ADDENDUM NO. 03

Project: Wastewater Treatment Facility Improvements
Walnut Ridge, Arkansas

The Contract Documents dated February 3, 2021, are hereby amended as follows:

Wastewater Treatment Facility Improvements

SCALE: 1/2" = 1'-0"

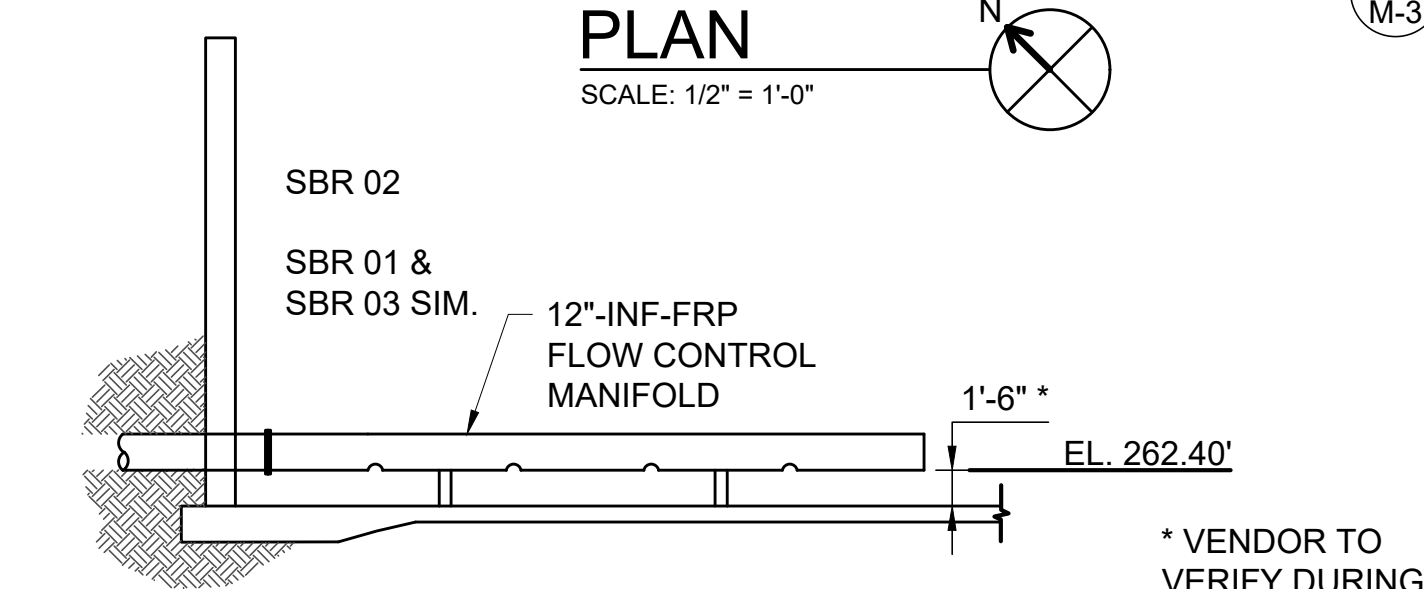
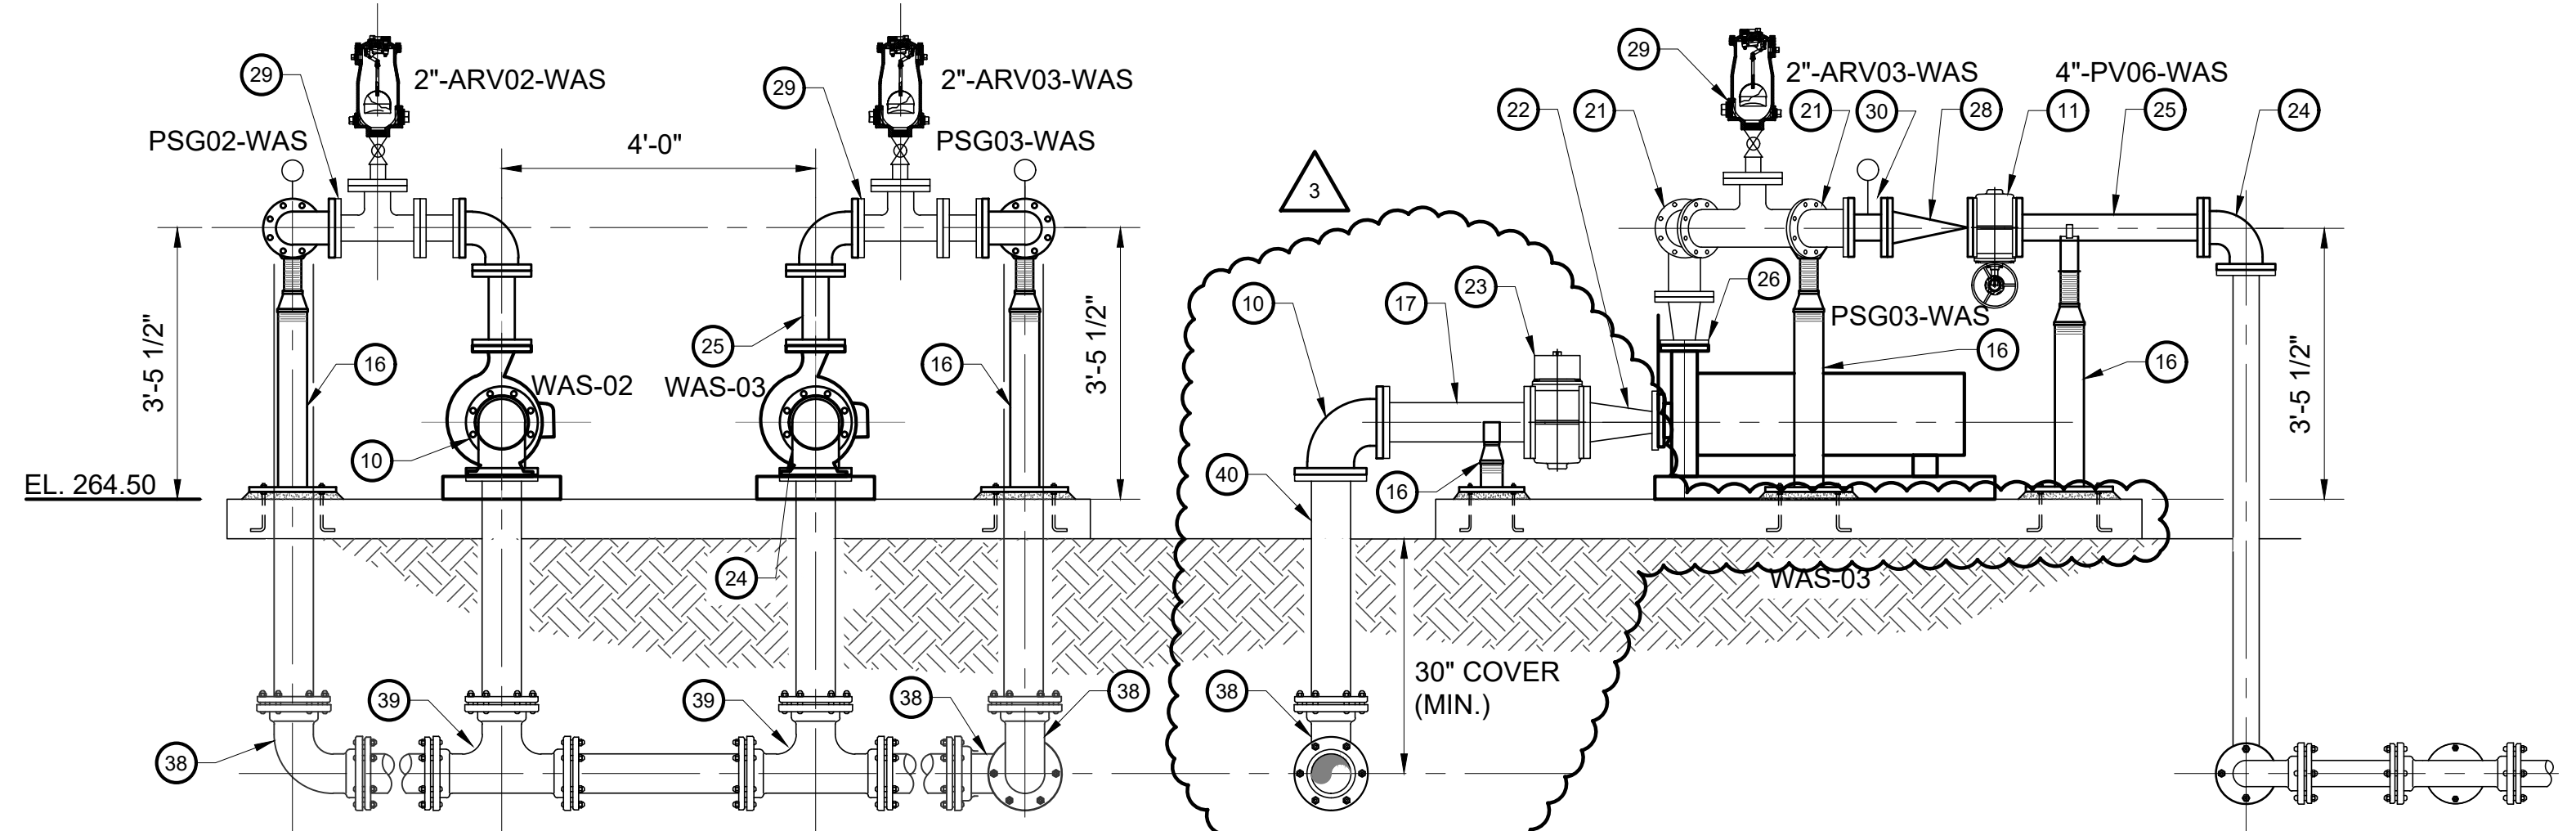
13. Drawing M-2 – SBR 01 Mechanical Plan and Sections:

- a. Modify this drawing as shown on the Addendum No. 3 – SBR 01 Mechanical Plan and Sections, attached hereto.

SBR 02 AND SBR 03 MECHANICAL PLAN AND SECTIONS

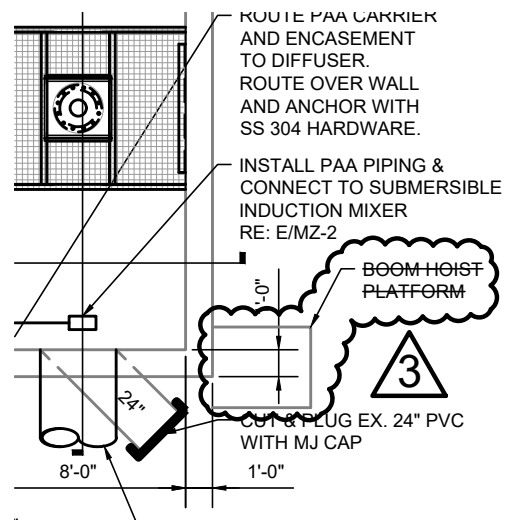
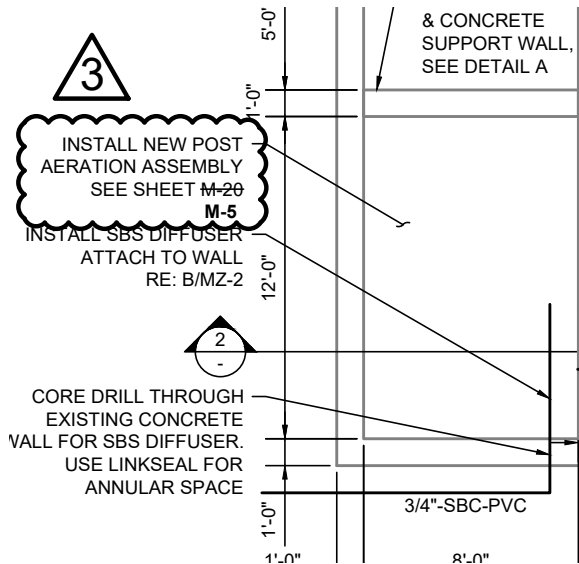
14. Drawing M-3 – SBR 02 and SBR 03 Mechanical Plan and Sections:

- a. Modify this drawing as shown on the Addendum No. 3 – SBR 02 and SBR 03 Mechanical Plan and Sections, attached hereto.

REV. NO.	DATE	DRWN	CHKD	REMARKS
1	02/24/21	MAB	CAJ	ENLARGED PUMP PAD TO ACCOMMODATE ADDITIONAL PIPE SUPPORT /CHANGED #16 MATERIAL SCH.

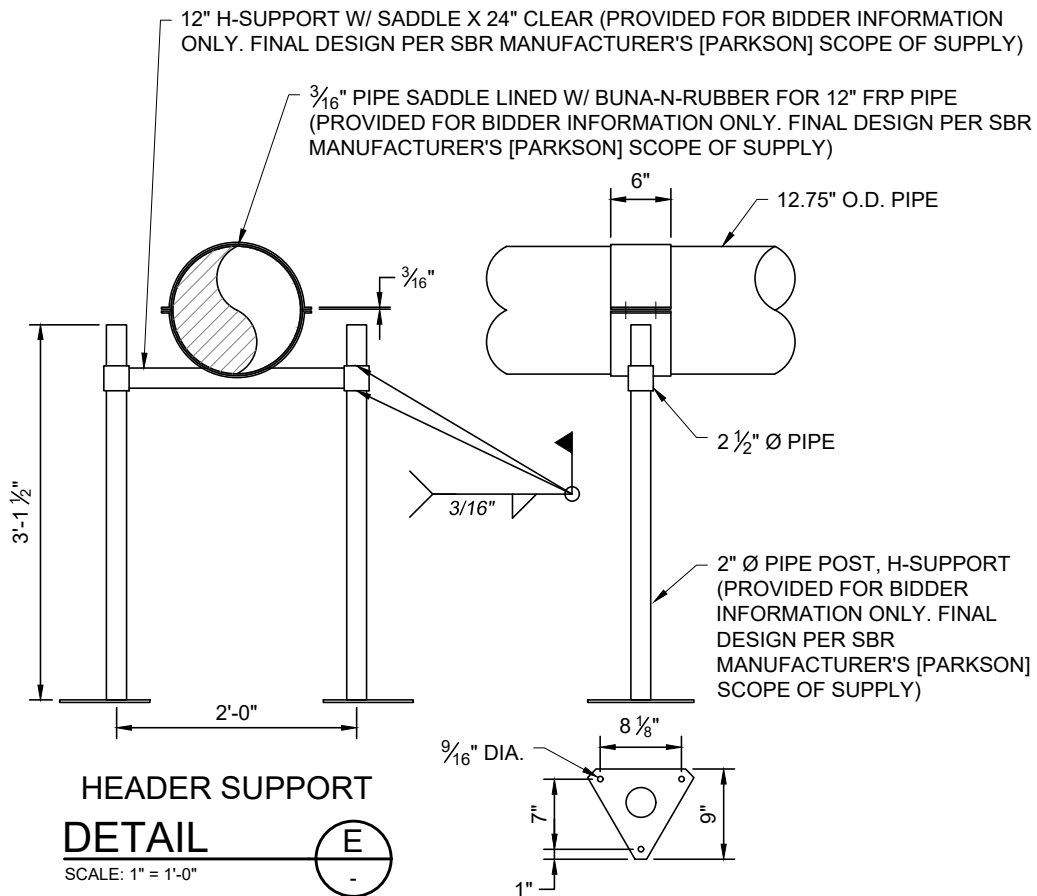
15. Drawing M-7 – Disinfection, Quenching, & Post Aeration Basin Improvements:

- a. Modify this drawing as shown on the Addendum No. 3 – Disinfection, Quenching, & Post Aeration Basin Improvements, attached hereto.

CRIST ENGINEERS, INC.	
CONSULTING ENGINEERS		LITTLE ROCK, ARKANSAS	
WALNUT RIDGE, ARKANSAS			
CITY WATER WORKS WWTF IMPROVEMENTS			
MECHANICAL STANDARD DETAILS II			
DESIGNED: CAJ	JOB NO: 1618	DATE: MAR 2021	ADD NO. 3
DRAFTED: SBM	SCALE: NOT TO SCALE	REF. SHEET MZ-2	
CHECKED: CAJ

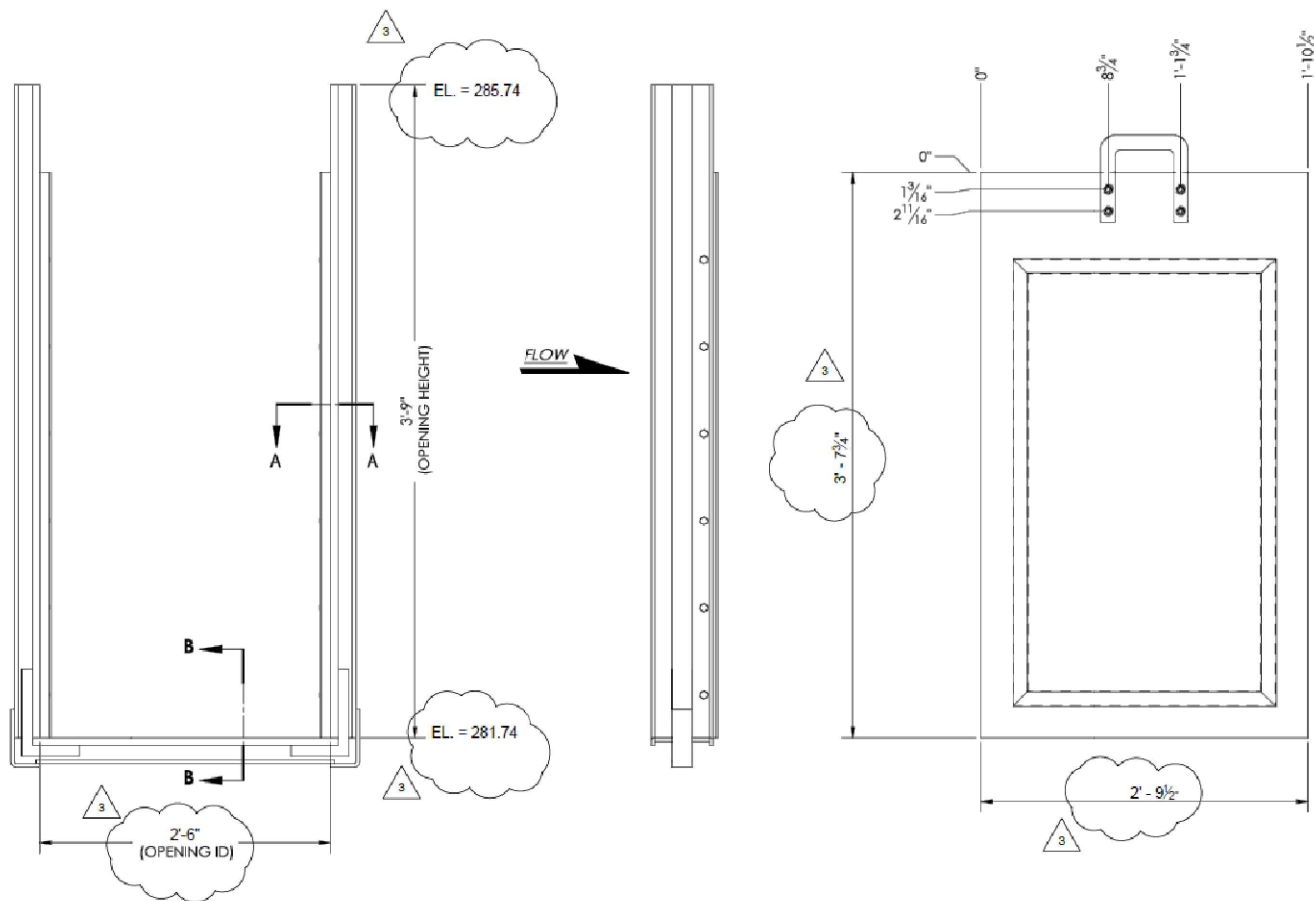
17. Drawing MZ-2 – Mechanical Standard Details II:

- a. Modify this drawing as shown on the Addendum No. 3 – Mechanical Standard Details II, attached hereto.

CRIST ENGINEERS, INC. CONSULTING ENGINEERS LITTLE ROCK, ARKANSAS	
WALNUT RIDGE, ARKANSAS CITY WATER WORKS WWTF IMPROVEMENTS	
MECHANICAL STANDARD DETAILS VIII	
DESIGNED: CAJ	JOB NO: 1618
DRAFTED: SBM	DATE: MAR 2021
CHECKED: CAJ	SCALE: NOT TO SCALE
ADD NO. 3 REF. SHEET MZ-8

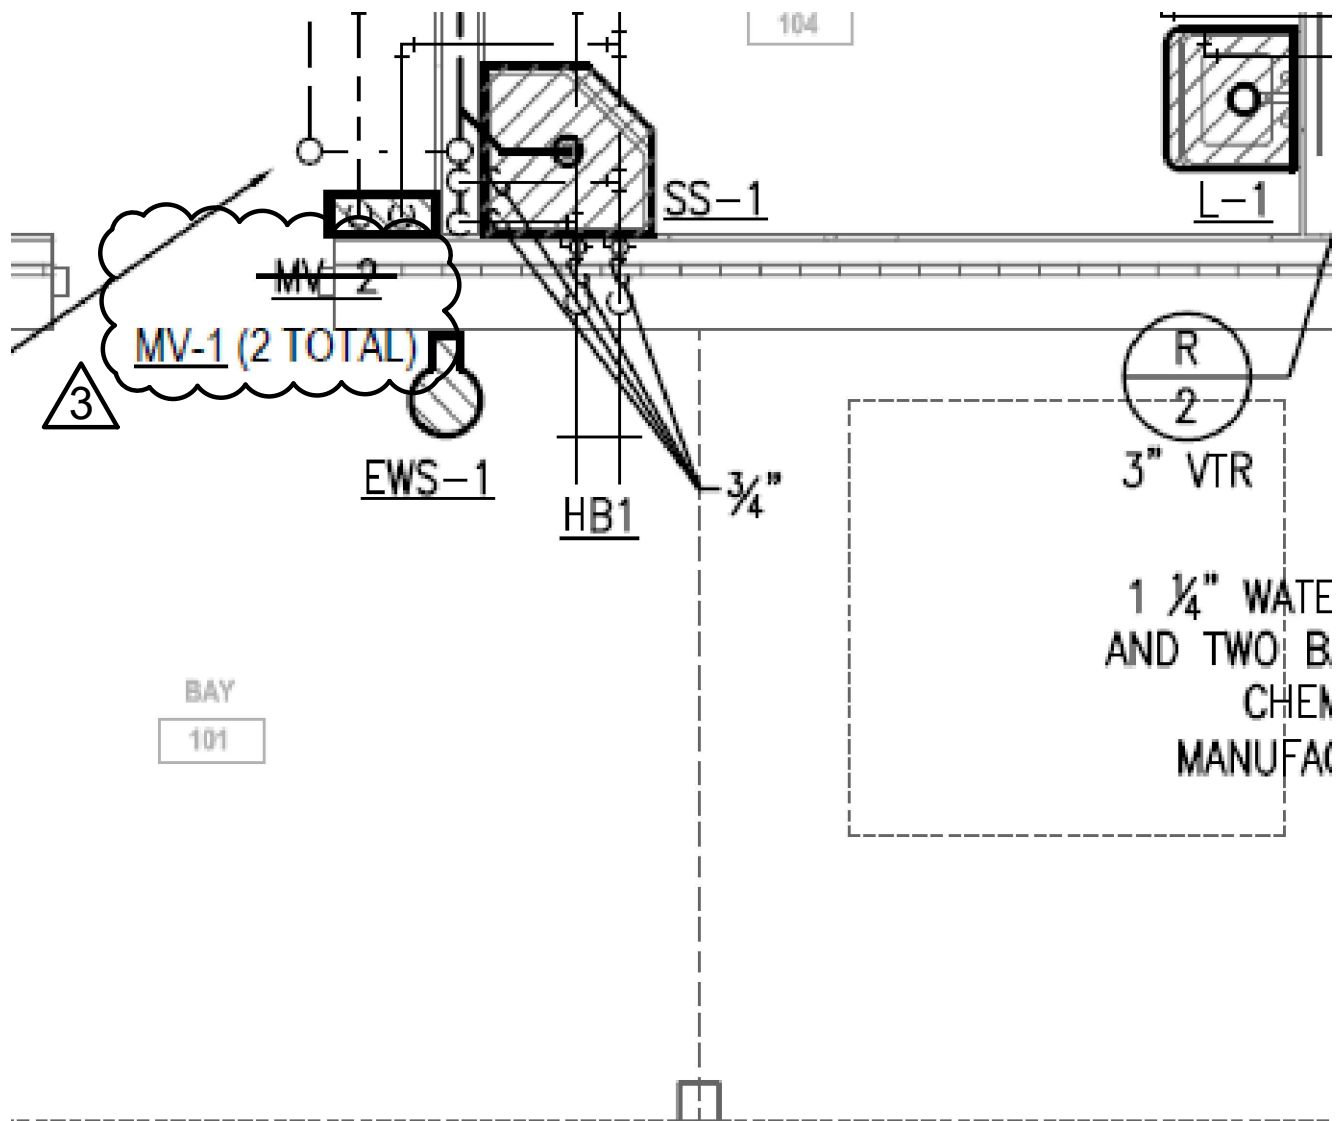
18. Drawing MZ-8 – Mechanical Standard Details VIII:

- a. Modify this drawing as shown on the Addendum No. 3 – Mechanical Standard Details VIII, attached hereto.

CRIST ENGINEERS, INC. CONSULTING ENGINEERS LITTLE ROCK, ARKANSAS		
WALNUT RIDGE, ARKANSAS CITY WATER WORKS WWTF IMPROVEMENTS			
PLUMBING PLAN, DETAILS, AND RISER			
DESIGNED: CAJ	JOB NO: 1618	DATE: MAR 2021	ADD NO. 3
DRAFTED: SBM	SCALE: NOT TO SCALE	REF. SHEET P-1	
CHECKED: CAJ

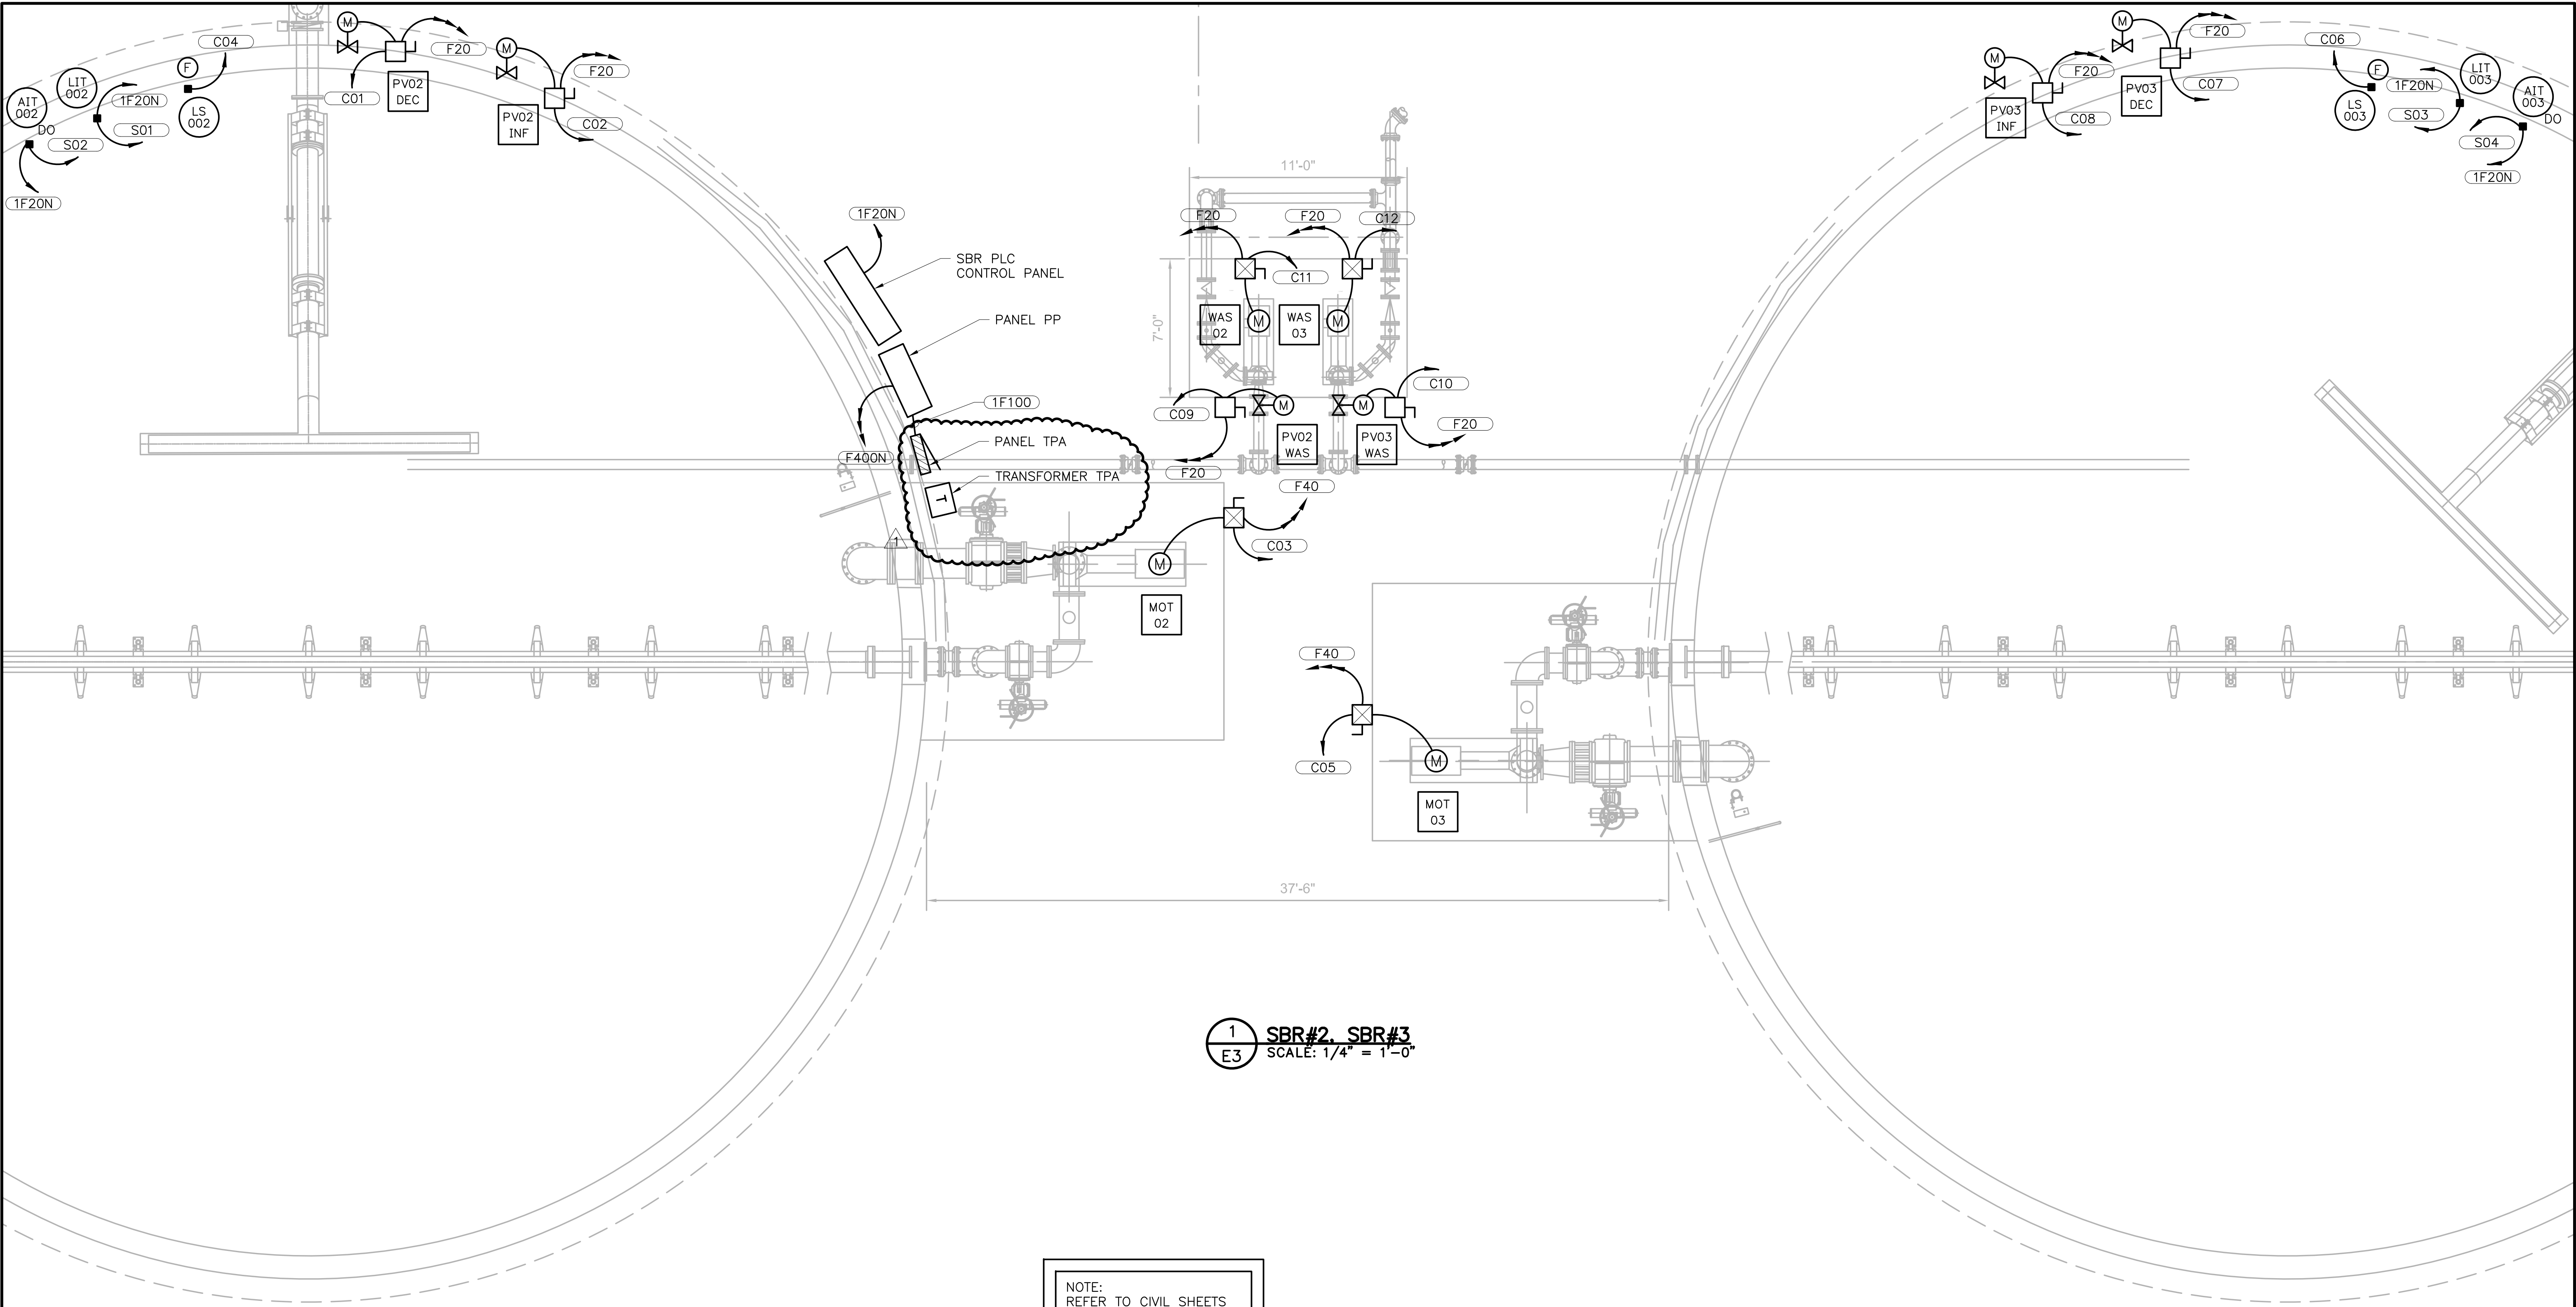
20. Drawing P-1 – Plumbing Plan, Details, and Riser:

- a. Modify this drawing as shown on the Addendum No. 3 – Plumbing Plan, Details, and Riser, attached hereto.
